New Airtex Improved Connector and Pigtail for GM Fuel Pump Modules

Airtex Manufactured GM Modules to be converted to 4 X 1 Connector:

Old Design—Top & Side View

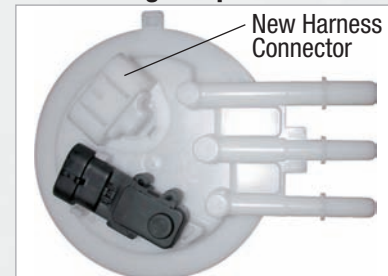
Many GM vehicles from 1988 to 2005 have electrical connectors on the fuel pump module that may become loose over time due to vibration, leading to faulty, high-resistance connections. The symptoms – burned or melted connectors and pins – lead to a voltage drop situation where low or no voltage can cause the module to stop pumping.

Airtex Products' latest fuel system solution provides a quick and reliable fix for burned or melted wiring harness connections on certain GM in-tank fuel pump applications. Airtex has replaced the faulty OEM design connector with a new OEM design that eliminates the burned or melted connectors and pins problem.

Fuel pump modules with the improved 4-pin connector require vehicle harness replacement. One of the five application-specific, color-coded vehicle wiring harnesses is included with every pump that uses the new connector.

New Design—Top & Side View

GM Fuel Pump Module with New Harness Connector
